Re: Forest Lodge Integrated Seniors Living (SSD-75493483) – Response to Submissions

In accordance with the Department’s Request for Additional Information dated 2 October 2025, this letter is provided to address the key issues and comments raised by the Department, City of Sydney and the agency advice received in response to the Environmental Impact Statement for SSD-75493483.

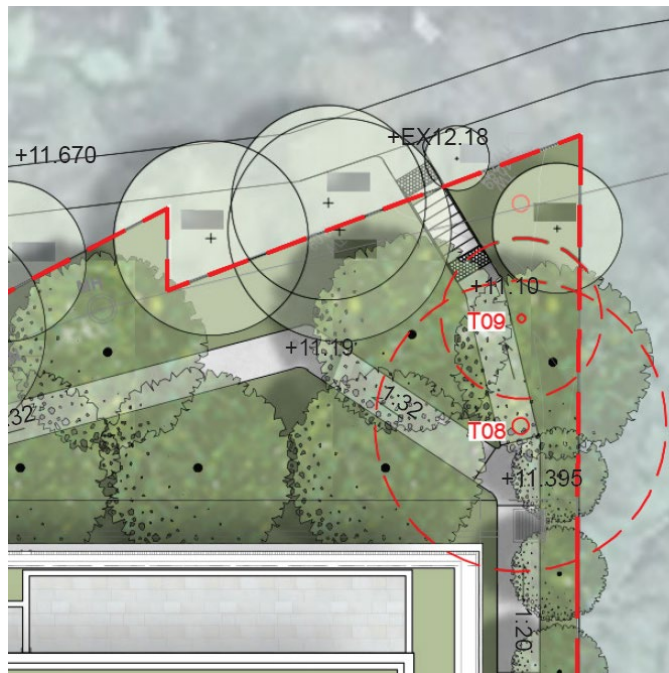
| Landscape Architecture | <p><i>The northwestern through-site link (Area F) must achieve a minimum width of 3m to provide sufficient space for pedestrian access path and mature screen planting along the entire length of the through-site link as required</i></p> |

by section 6.3.12.5(7) of the Sydney SDCP 2012. The grades of the through-site link are to comply with AS1428.

The northwestern site through link is now 3m wide, divided into a 500mm planting strip with climbers traversing the architectural battens, a 1.3m wide walkway at 1:20, and a 1.2m strip of screening planting at the boundary, consisting of Magnolia trees and shade tolerant plants.

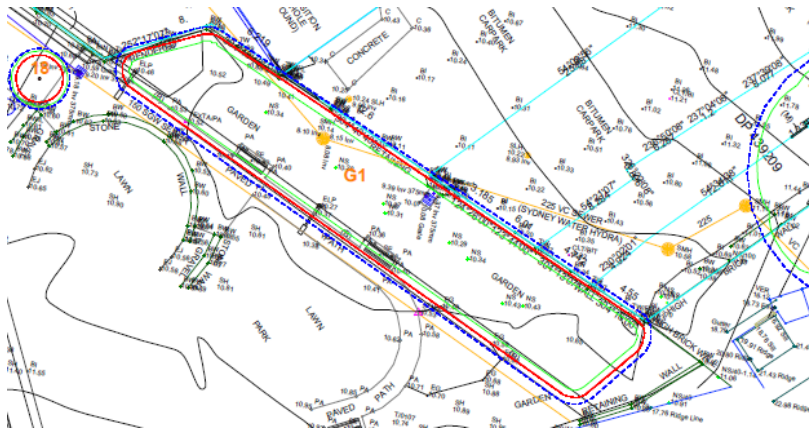
A direct connection between the northwestern through-site link and the existing footpath to Orphan School Creek should also be considered to serve the desire line for people travelling to/from Orphan School Creek.

A direct connection has been designed to accommodate the desire line between the site through link and existing footpath to Orphan School Creek. Details for this can be found in the landscape report on page 14.
